Item Name: Quick Release Heli-Utility-Basket™ Long, HD Lid, Spacepod™/Squirrel Cheek Comp.

DART SERVICE INSTRUCTION

TO AMEND INSTALLATION INSTRUCTIONS D350-607-3 Rev.D,
INSTALLATION INSTRUCTIONS D350-607-4 Rev. C AND
INSTRUCTIONS FOR CONTINUED AIRWORTHINESS ICA-D350-607 REV. 6
REF TCCA STC: SH94-14
REF FAA STC: SR00213NY
REF EASA STC: EASA.10016996
REF BRAZILIAN STC: 2007S03-03/-04/-05/-06

A	NEW ISSUE	AJS	14.05.16
REV.	DESCRIPTION	BY	DATE
DESIGN	AJS	DART AEROSPACE LTD HAWKESBURY, ONTARIO, CANADA	
DRAWN	AJS		
CHECKED	N/A	DRAWING NO.	REV. A
MFG. APPR.		DSI 9699	SHEET 1 OF 2
APPROVED		TITLE	SCALE
DE APPR.		LUG REPLACEMENT	NTS
DATE	14.05.16	COPYRIGHT © 2014 BY DART AEROSPACE LTD THIS DOCUMENT IS PRIVATE AND CONFIDENTIAL AND IS SUPPLIED ON THE EXPRESS CONDITION THAT IT IS NOT TO BE USED FOR ANY PURPOSE OR COPIED OR COMMUNICATED TO ANY OTHER PERSON WITHOUT WRITTEN PERMISSION FROM DART AEROSPACE LTD.

FIGURE 1: INSTALLATION OF D4775-041 FWD STRUT

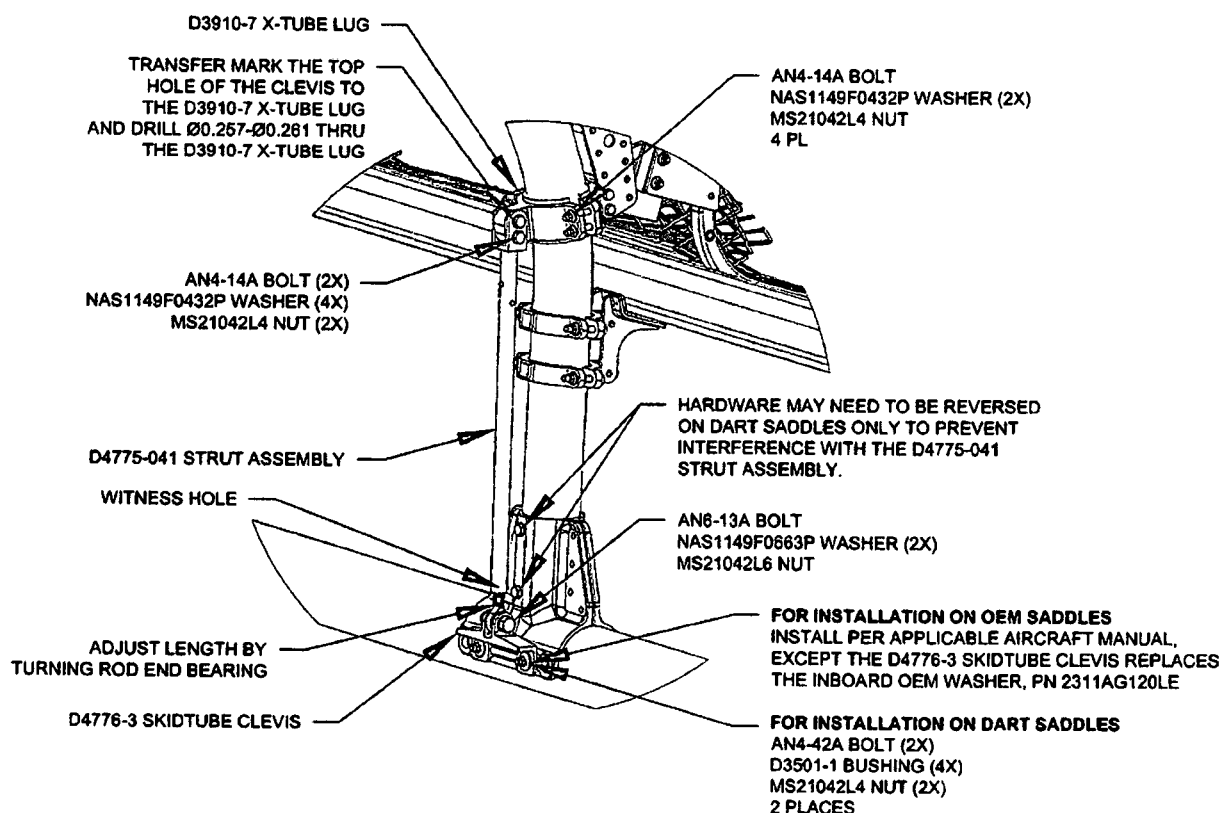
- 3.1 Substitute the Forward Lower D3910-5 X-Tube Lug with the D3910-7 X-Tube Lug as shown in Figure 1.
- 3.2 Install the forward D4775-041 Strut Assembly. Transfer mark from the upper hole on the clevis of the D4775-041 Strut Assembly to the D3910-7 X-tube Lug and drill thru the lug $\varnothing 0.257$ - $\varnothing 0.261$ as shown in Figure 1. Touch up chemical conversion coating per MIL-DTL-5541. Check the witness holes located at the bottom end of the D4775-041 Strut Assemblies to ensure that the thread from the rod end extends past the witness hole.
Torque MS21042L4/-4 nuts to 50-70 in-lbs (5.7-7.9 N-m). Torque MS21042L6/-6 nuts to 160-190 in-lbs (18.1-21.5 N-m).
- 3.3 Complete the installation in accordance with Installation Instructions D350-607-3 Rev. D or D350-607-4 Rev. C.
